BID ADDENDUM NO. 1

City of Auburn, Maine
South Main Street Roadway Reconstruction: Phase III
April 1, 2016

Notice is hereby given that Addendum No. 1 provides further clarification for questions asked by Bidders before and during the Pre-Bid meeting held on March 29, 2016, and includes the Pre-bid attendance list. Bidders are instructed to acknowledge receipt of this Addendum by inserting its number and date in the "Acknowledgement of Bid Amendments".

PHASE III
PLAN & PROFILE
STA. 5+50 – 10+00

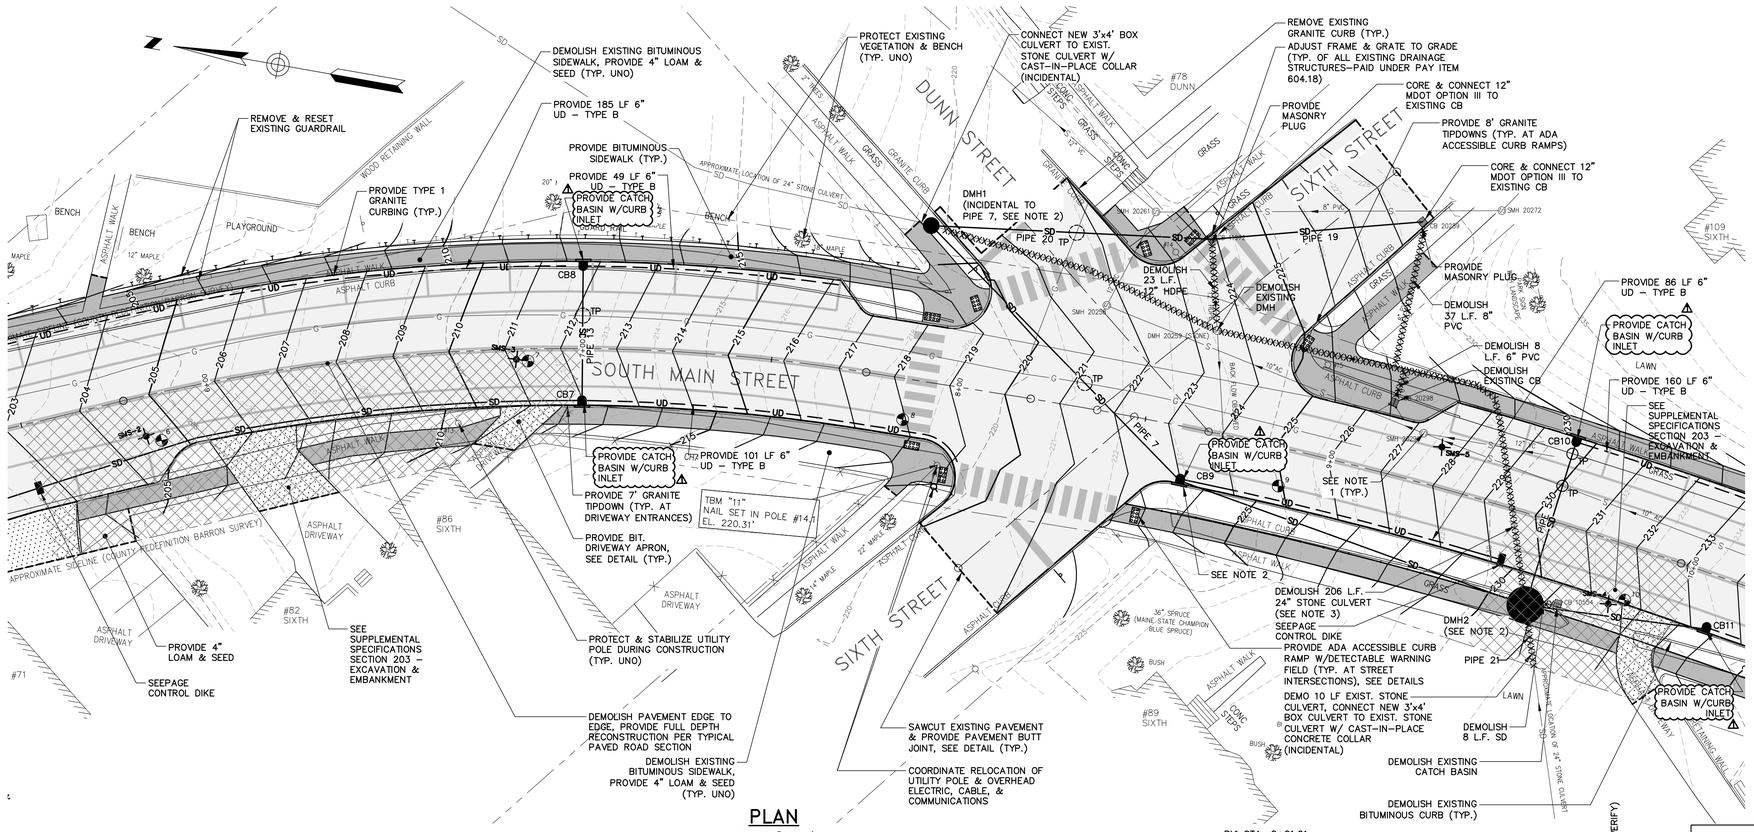
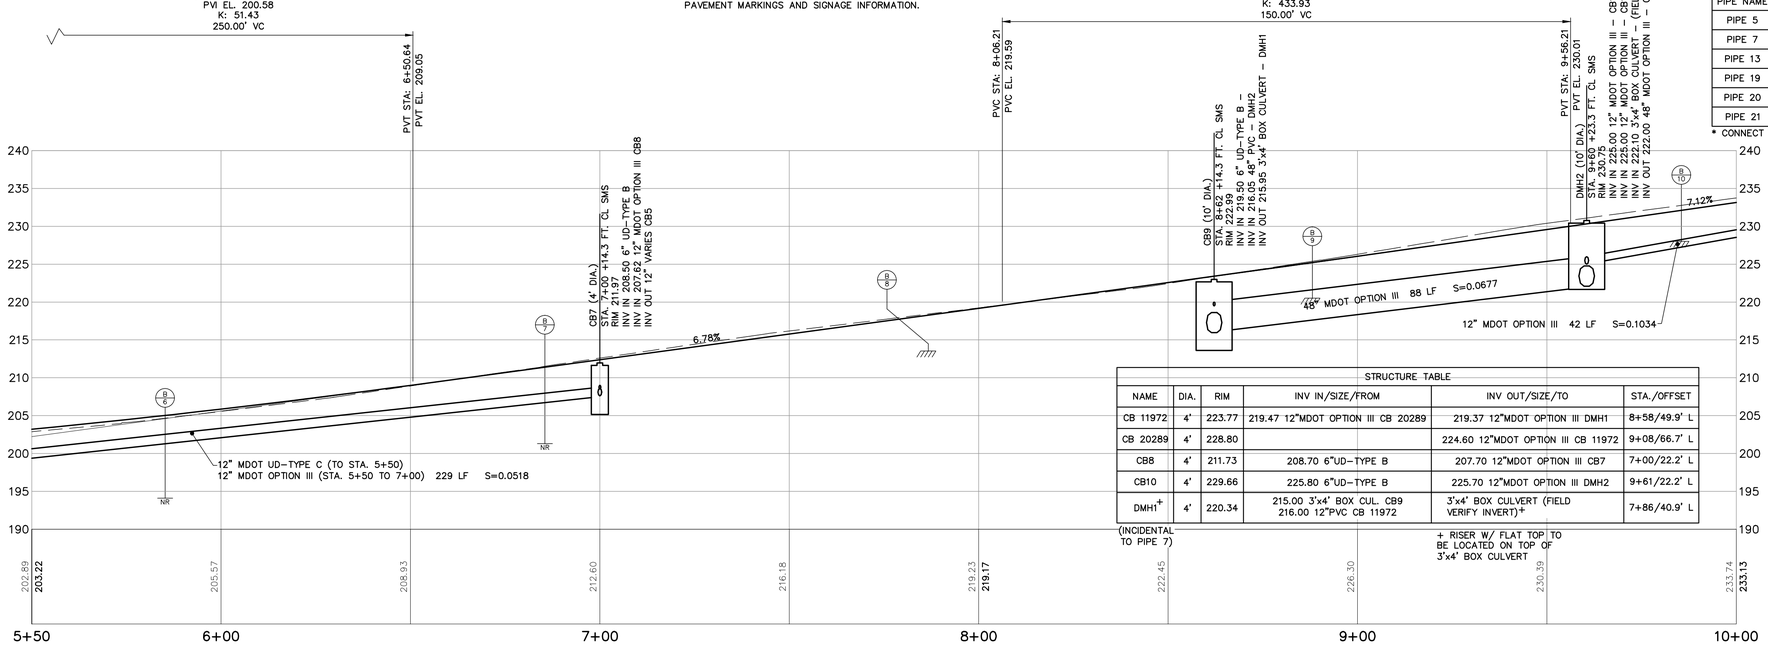
2. Question: The structure table on Sheet C-201 identifies DMH 1 as a 4-foot diameter manhole, but it is located at the connection of the new box culvert and the existing stone culvert. Does this structure need to be upsized? Also, could you provide a detail for the concrete collar?
   Answer: DMH 1 is intended to be a precast riser extending from the top of the box culvert. Details of DMH 1 and the concrete collar have been added to the drawings; see Drawing section of this Addendum for amendments to the drawings.

Contractor shall field verify the inverts of the existing stone box culvert and provide them to the City for review prior to ordering DMH 1, DMH 2, CB 9 and the precast box culvert.

1. FOR ALL EXISTING SEWER MANHOLES, CONTRACTOR SHALL REMOVE COVER AND FRAME AND PROVIDE STEEL PLATE TO COVER OPENING. OFFSETS SHALL BE INSTALLED TO DETERMINED LOCATION. THE AUBURN WATER AND SEWERAGE DISTRICT WILL BE RESPONSIBLE FOR ADJUSTING FRAME AND COVER TO GRADE, INCLUDING EXISTING CURB STOPS TO REMAIN (INCIDENTAL TO CONTRACT).
2. FIELD VERIFY INVERTS OF EXISTING STONE CULVERT AND PROVIDE TO RESIDENT FOR REVIEW AND APPROVAL PRIOR TO ORDERING STRUCTURES DMH1, DMH2 AND CB9 AND PIPES 7 & 21. NOTIFY RESIDENT OF ANY CONFLICTS.
3. CONTRACTOR OPTION: DEMOLITION OF STONE CULVERT MAY INCLUDE REMOVAL OF CULVERT TOP AND INFILLING STRUCTURE.

+ RISER W/ FLAT TOP TO BE LOCATED ON TOP OF 3'x4' BOX CULVERT

PRECAST BOX CULVERT DETAILS

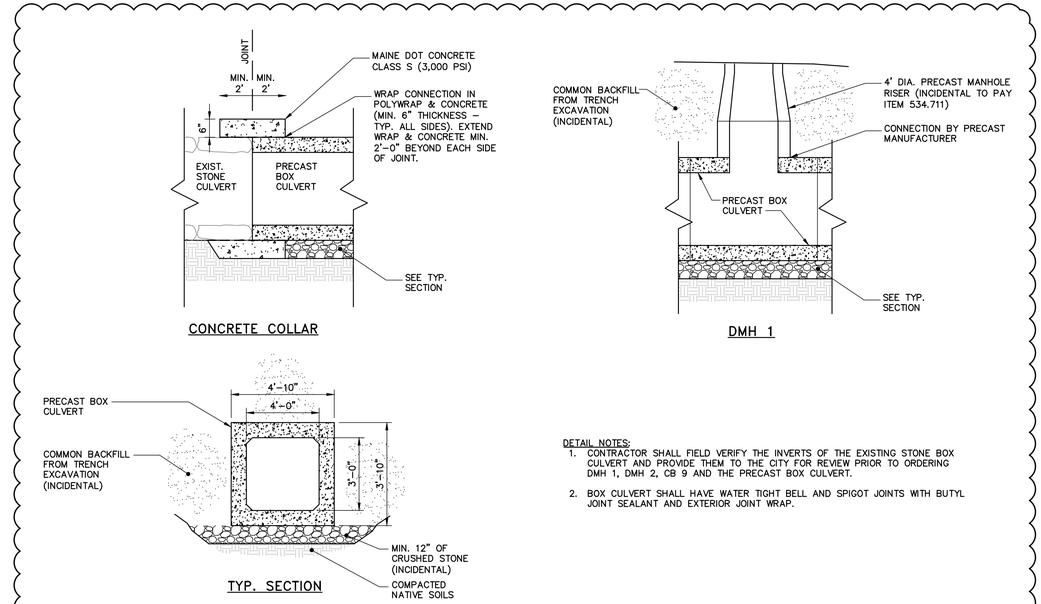
1. Question: Can you provide details for the precast box culvert? Could you clarify the testing requirements for the precast box culvert?
   Answer: The requirements of MaineDOT Standard Specifications Subsections 543.05 - *Facilities for Inspection* and 534.14 - *Process Control Test Cylinders* will not be required for the precast box culvert. Shop drawings for the precast box culvert shall be stamped and signed by a licensed Professional Engineer registered in the State of Maine; see Specification section of this Addendum for amendments to the specifications.

Details for the precast box culvert have been added to the drawings; see Drawing section of this Addendum for amendments to the drawings.

DETAIL NOTES:
1. CONTRACTOR SHALL FIELD VERIFY THE INVERTS OF THE EXISTING STONE BOX CULVERT AND PROVIDE THEM TO THE CITY FOR REVIEW PRIOR TO ORDERING DMH 1, DMH 2, CB 9 AND THE PRECAST BOX CULVERT.

2. BOX CULVERT SHALL HAVE WATER TIGHT BELL AND SPIGOT JOINTS WITH BUTYL JOINT SEALANT AND EXTERIOR JOINT WRAP.
